ATTACHMENT 1

SAFETY LIMITS AND POWER DISTRIBUTION

TS MARK-UPS

RELOAD REPORT
Catawba Unit 1, Cycle 6

Figure 2.1-1a Reactor Core Safety Limits - Four Loops in Operation (UNIT 1)

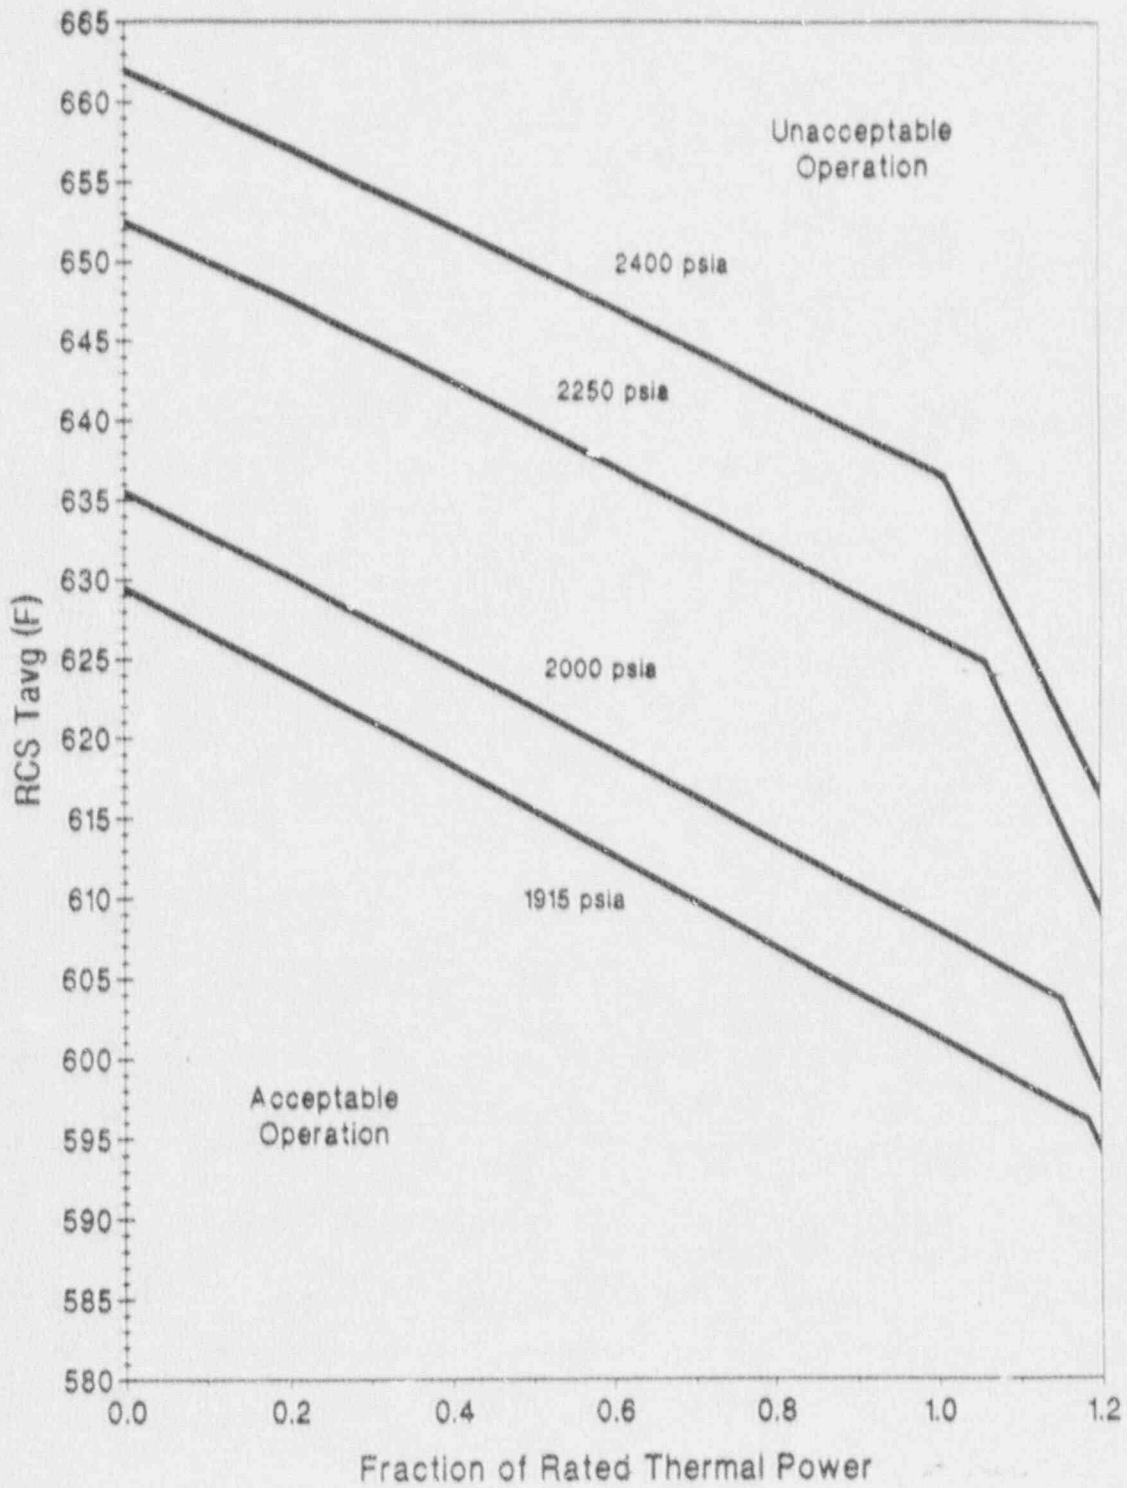
This proposed Technical Specification (TS) revision changes Figure 2.1-1 to reflect use of the BWCMV CHF correlation and B&W Fuel Company's Statistical Core Design (SCD) methodology with a 1.50 thermal design limit. The new figure applies to Unit 1 only. The figure numbers and references in T.S. 2.1.1 have been changed to indicate the correct Figure 2.1-1 for each unit.

The reactor core safety limits provided on Figure 2.1-1 depict the combinations of thermal power, reactor coolant system pressure, and average temperature below which the calculated DNBR is no less than the design limit DNBR value, or the average enthalpy at the vessel exit is less than the enthalpy of saturated liquid. The analysis which defined these limits was based on a full core of Mark-BW assemblies with a thermal design flow rate that bounded the minimum measured flow at Catawba. The DNB limited portions of these curves were defined using the BWCMV CHF correlation with a thermal design limit of 1.50. This 1.50 thermal design limit provided 10 percent thermal margin to the 1.345 BWCMV statistical design limit which was defined for the Catawba core using the BWFC SCD methodology. The safety limits were based on a design peaking distribution with a nuclear enthalpy rise hot channel factor, $F_{\Delta H}^N$, of 1.55 and a reference cosine axial power shape with a peak of 1.55. To verify that this design peaking distribution was conservative on a cycle-specific basis, maximum allowable peaking (MAP) limits

FIGURE 2.1-1b

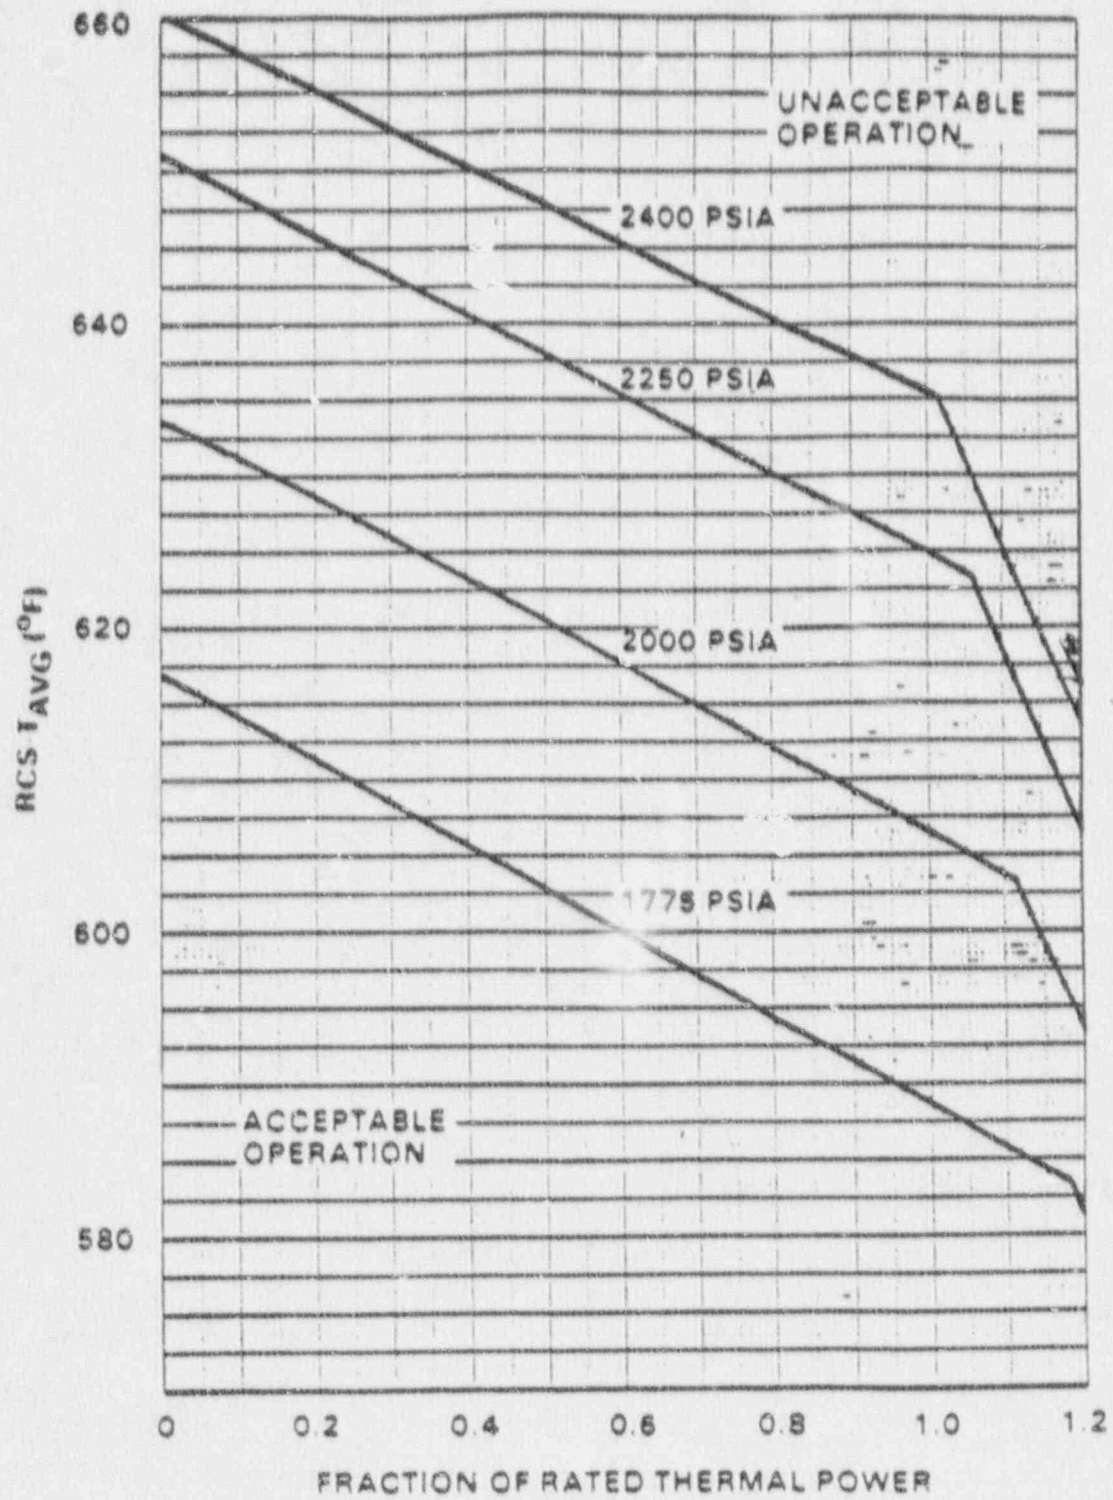
An administrative change is being made to the TS which apply to Unit 2, and no longer apply to Unit 1 after the reload. The current Figure 2.1-1 has been relabeled as applicable to Unit 2 only. Table 2.2-1 also notes that the the existing Reactor Coolant flow applies only to Unit 2 and the new Reactor Coolant flow (96,250) applies to Unit 1. The Applicability Section of the Power Distribution TS (3/4.2.1, 3/4.2.2, 3/4.2.3, 3/4.2.4) have also been revised to show that the existing TS still apply to Unit 2. The existing TS will be copied on yellow paper to further distinguish them from the new TS which apply to Unit 1 only. The Power Distribution TS will have an "A" in the page number for Unit 1 and a "B" for Unit 2, the pages will also be marked "Unit 1" or "Unit 2". This change is administrative only, and is being made to distinguish between the TS for Unit 1, which will be operated with TS revisions which reflect the use of Mark-BW fuel, and Unit 2 which will continue to operate with Westinghouse supplied fuel.

Figure 3.2-1. Reactor Coolant System Total Flow Rate Versus Rated Thermal Power - Four Loops in Operation (UNIT 1)

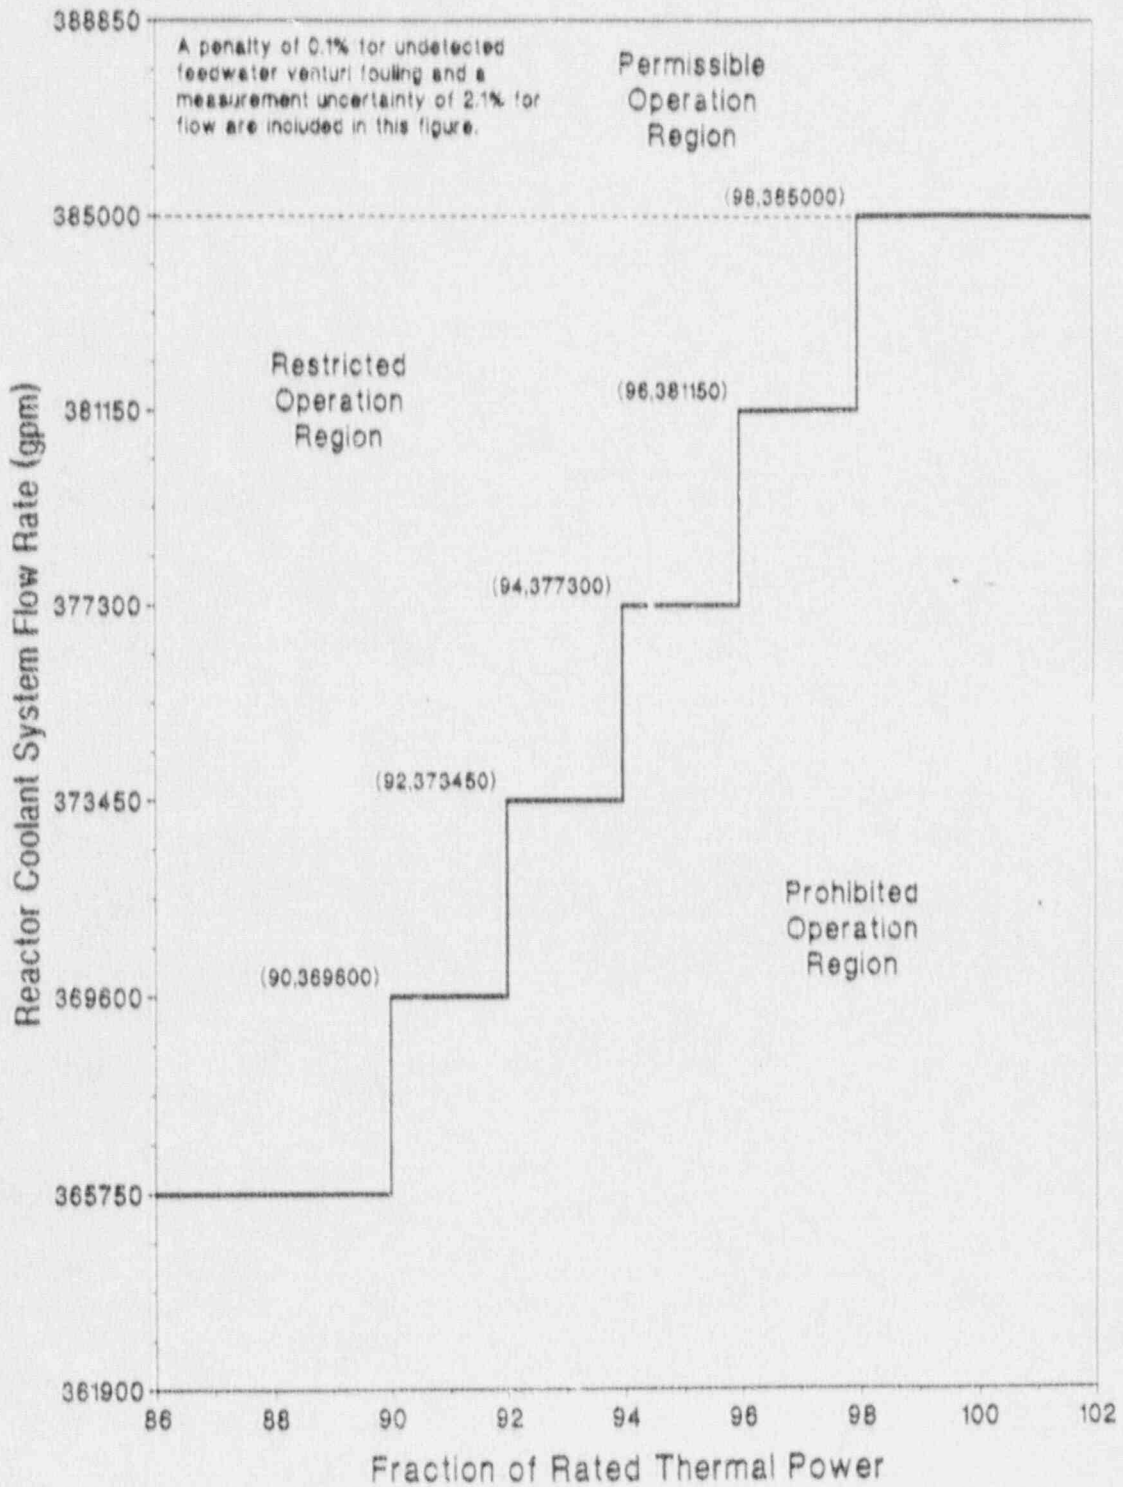
This proposed Technical Specification (TS) revision changes TS 3.2.5 to include a new figure that defines power reduction requirements for low flow operation. This new figure, Figure 3.2-1, replaces Figure 3.2-3 which had previously been relocated from Specification 3.2.3 to Figure 8 of the COLR.

Although Figure 3.2-3 had previously been moved to the Core Operating Limits Report (COLR), the new figure, Figure 3.2-1, is being returned to the plant Technical Specifications, since the parameters that are governed by the figure (power and flow) do not change on a cycle by cycle basis.

Figure 3.2-1 defines the trade-off in power and flow that will maintain the bases of the core safety and operating limits for a low flow condition. The analysis that verifies this trade-off considered a flow reduction down to 95 percent of the thermal design flow rate. To verify the validity of the trade-off, several DNBR evaluations were performed. These evaluations demonstrate that the Overtemperature ΔT safety limits remain valid as flow is reduced and that the specified reduction in operating power level produces improved DNBR margins for the limiting conditions II event. All reduced power statepoints considered the increase in allowable core peaking at reduced power consistent with Technical Specification 3.2.3. Therefore, no additional limits on the maximum Nuclear Enthalpy Rise Hot Channel Factor are required due to reduced flow conditions, thereby removing the R dependence.
